MEETING NOTICE – SITE REVIEW COMMITTEE

RE: 5060 Founders Terrace., HB-523-7; Wall Signage

ISSUE: Discussion and action two proposed wall signs

RECOMMENDATION: Staff recommends approval of the proposed wall signage as submitted.

WEST ELEVATION

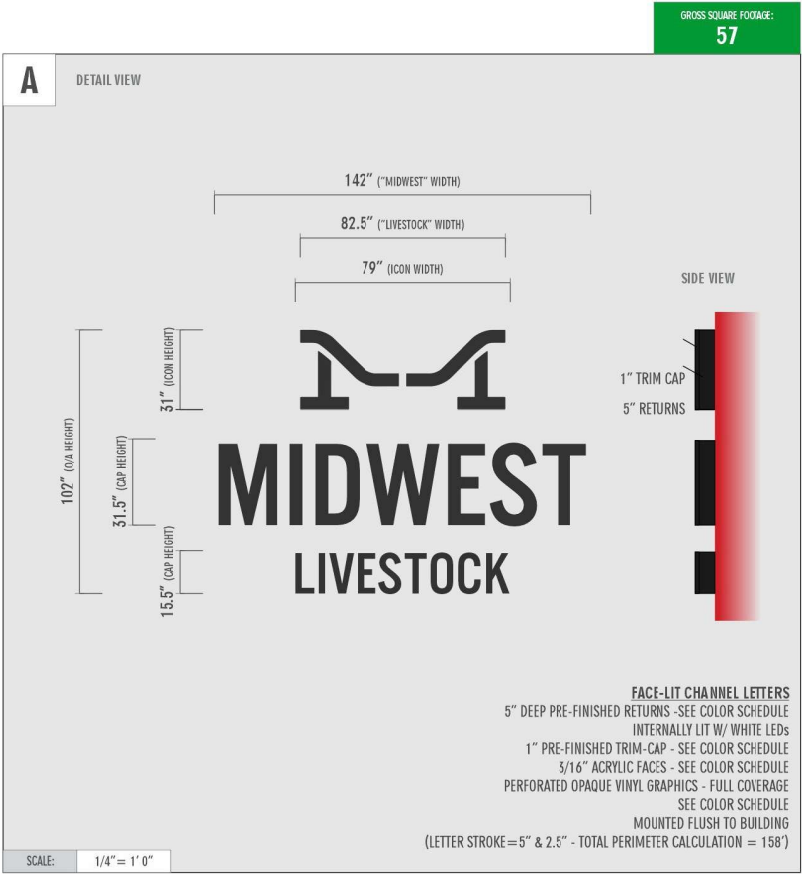
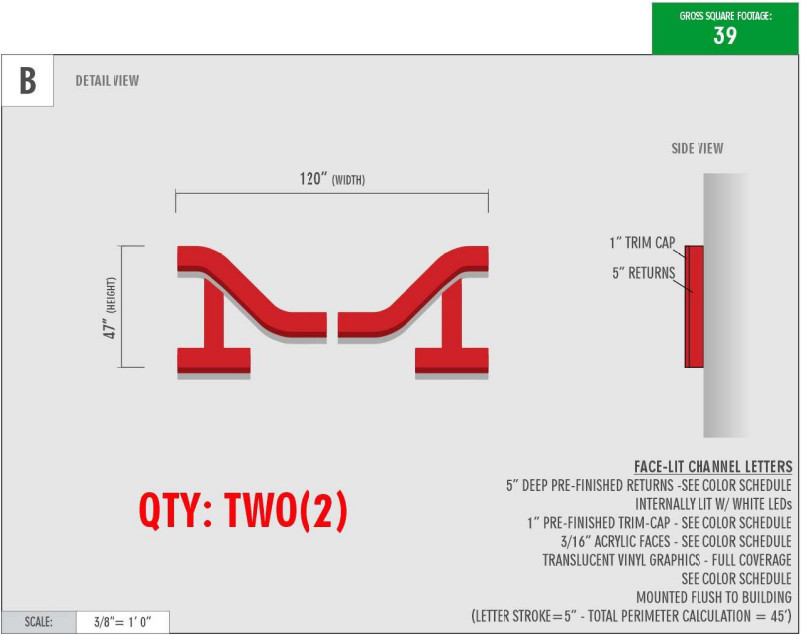
The request before the Committee at this time would be for two internally illuminated (face-lit) channel letter wall signs of a total of 39.17 square feet for the logo sign on the south building elevation, and a total of 96.12 square feet (39.17 (logo) and 56.95 (business name)) on the west building elevation. There will be signage located on each of the office store fronts facing Centerline Dr. and Founders Terrace. Since this is a corner parcel, the development is allowed to have one wall sign facing each roadway. Both wall signs are compliant with the Village Sign Code.

Staff recommends approval of the proposed two wall signs of 39.17 square feet for the logo sign on the south building elevation, and a total of 96.12 square feet (39.17 (logo) and 56.95 (business name)) on the west building elevation of the new building located at 5060 Founders Terrace as submitted.
